DRB Plan Review - Fail Fernanda Sotelo Ph: email: FernandaSotelo@miamibeachfl.gov

LEHRMAN COMMUNITY DAY SCHOOL
727 Lehman Drive / 77th St | Miami Beach, Florida 33141

FINAL DRB SUBMISSION

C1

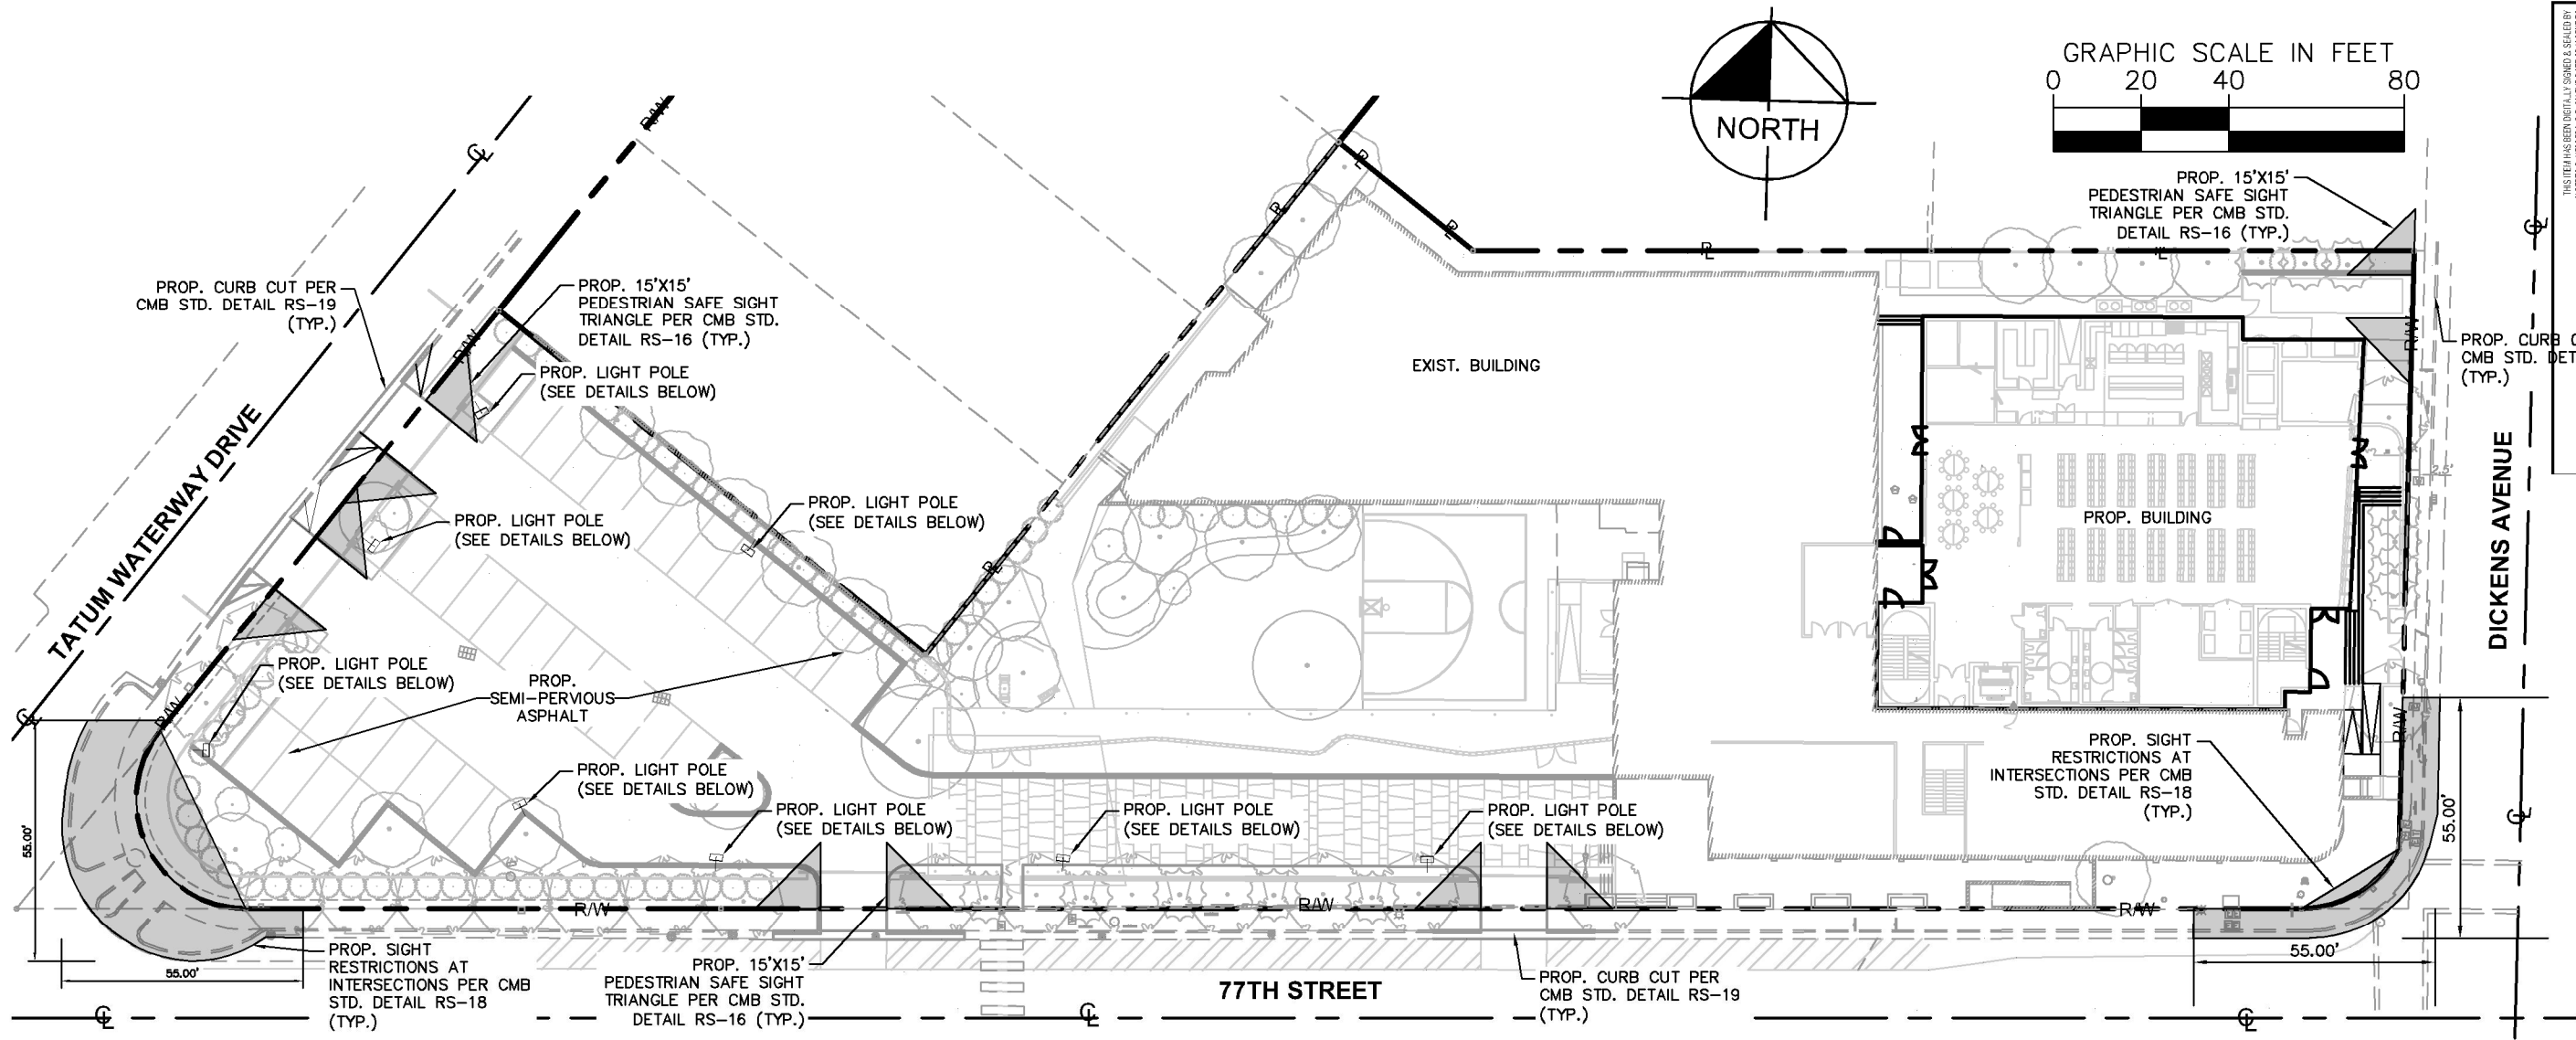
a. Where is parking lot lightings? Height of poles?

Parking lot lightings are shown on sheet. The poles are in height.

Please refer to sheet number C1 for our light pole exhibit. This exhibit reflects the light pole locations and also the 13' mounting height of the poles. Additionally, landscape uplights are shown on sheet L4.

TREE DISPOSITION & PROTECTION PLAN

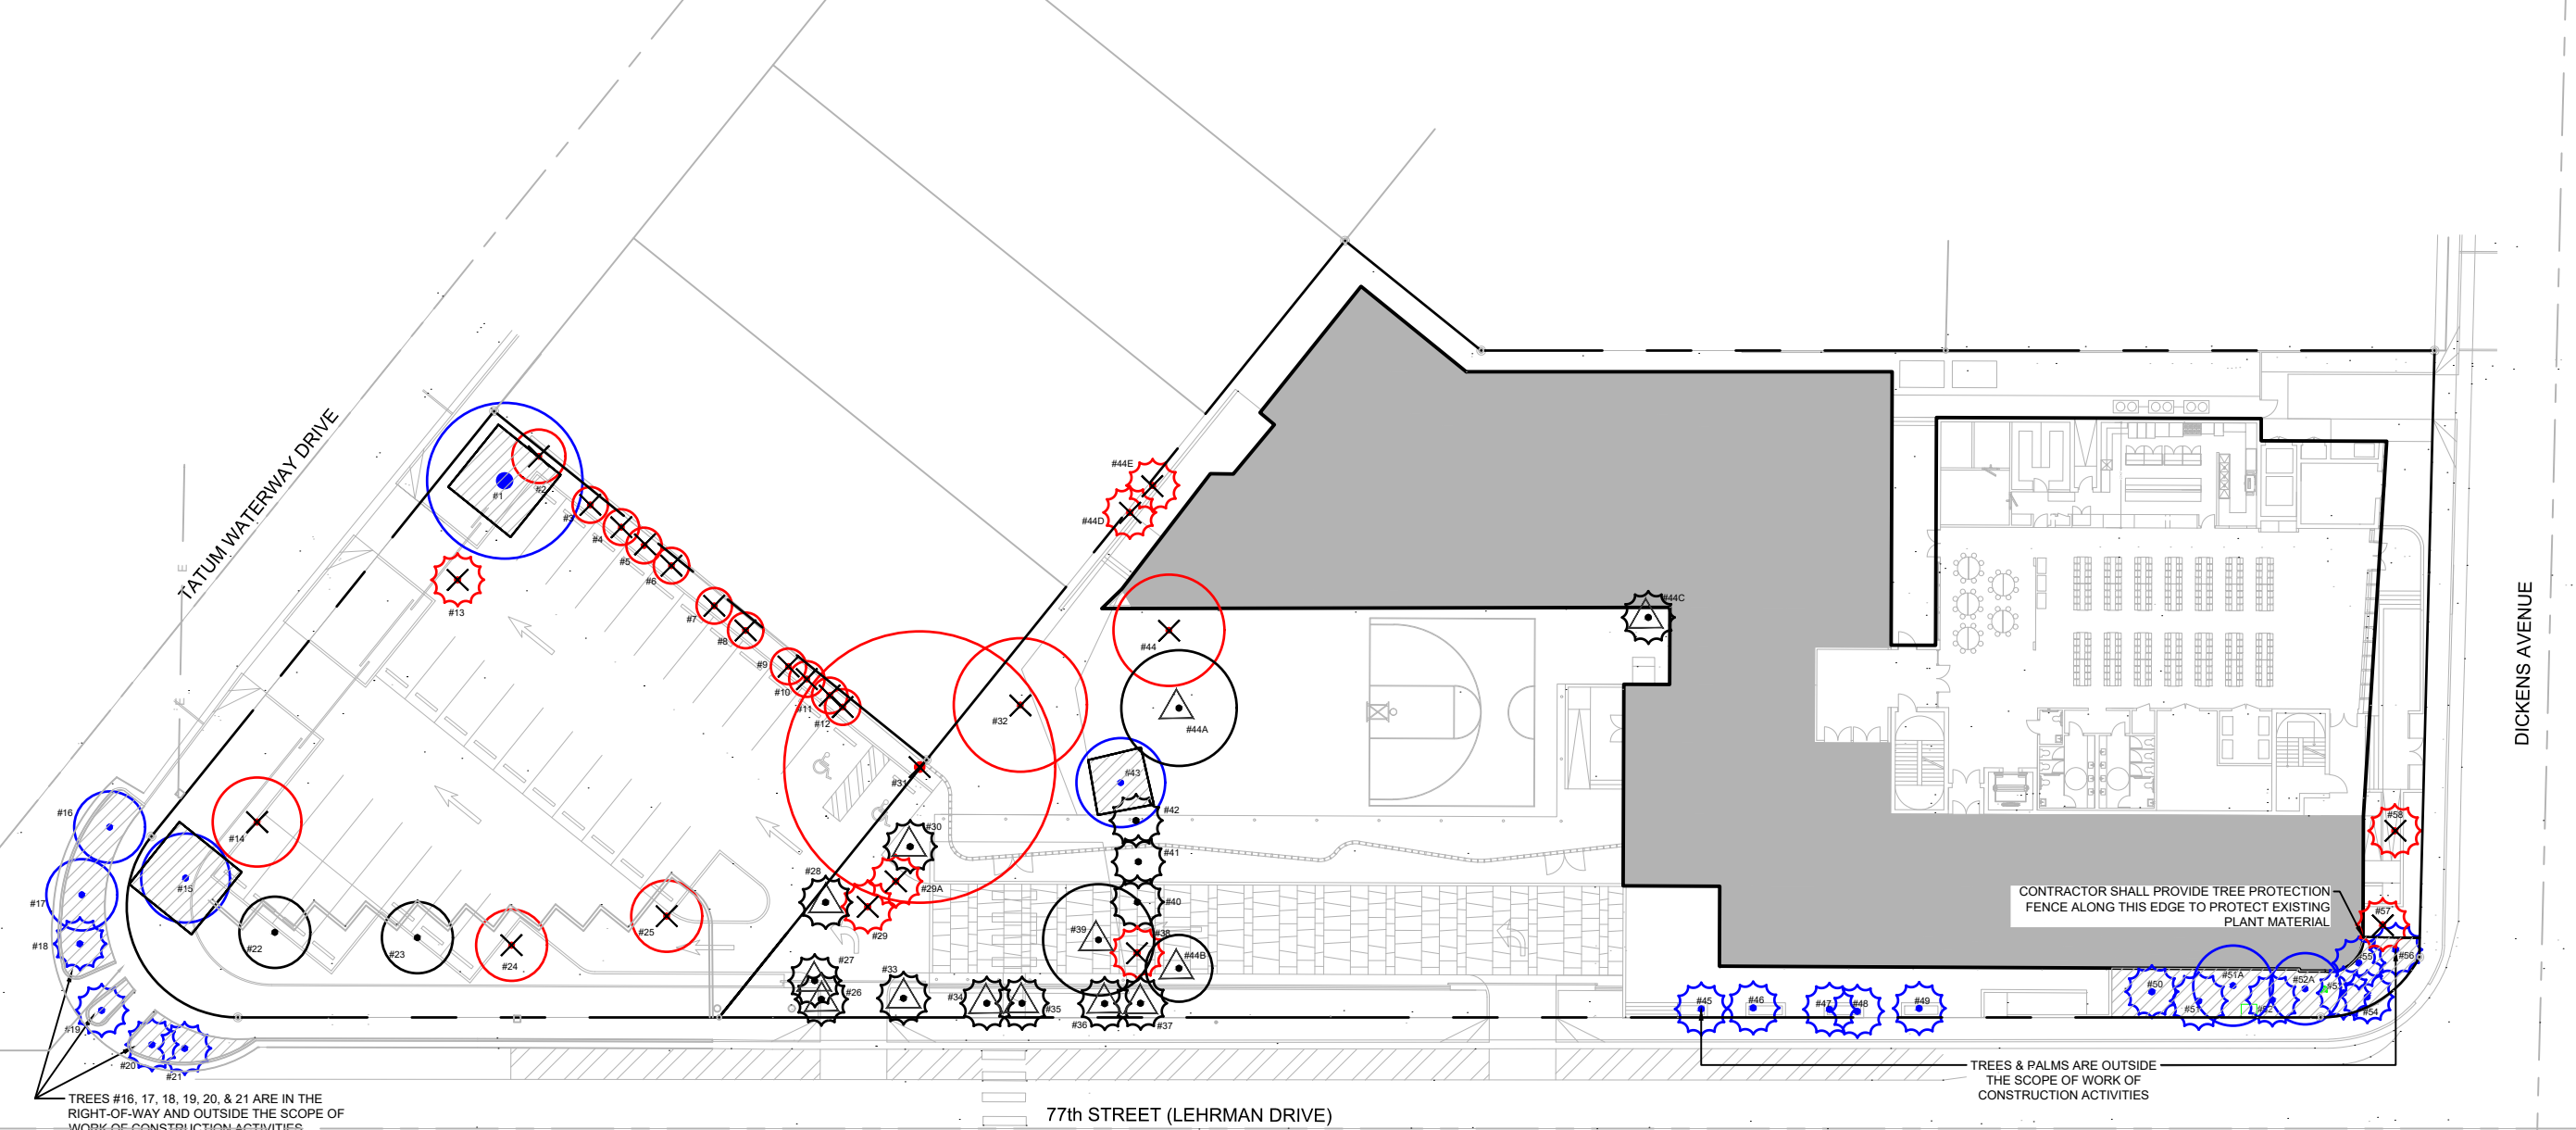
Tree preservation plans

The Specimen trees on property shall be preserved if identified to be in good condition by the certified arborist.

1. Tree Protection fence for existing trees and palms to remain shall consist of a 4' chain link fence with metal posts as per CMB Code Chapter 46. Please graphically show the location of fence to the dripline on the Tree Disposition Plan.

2. For permit plans, replace tree protection fence detail with approved CMB detail described in comment #1. Plastic mesh fencing is prohibited.

Tree disposition / preservation plan has been provided and coordinated with the recommendations noted by the arborist. All trees to remain are indicated on this plan.

Specimen trees on the property identified to be in good condition by the certified arborist have been preserved on the property, with the exception of tree #44 which has a codominant branch/trunks and will become structurally weak as it grows according to the arborist report.

Tree Protection fence detail consistent with CMB Code Chapter 46 for existing trees and palms has been added to sheet L2A Tree Protection Fence Detail. The location of the fence has been graphically shown to the dripline on the Tree Preservation / Disposition Plan, unless it is acceptable to be smaller per the arborist report. Some of the larger trees have 30'+ canopies but are listed with a 12'-18' TPZ/CRZ per the arborist report.

Noted. Tree Protection fence detail consistent with CMB Code Chapter 46 for existing trees and palms has been added to sheet L2A.
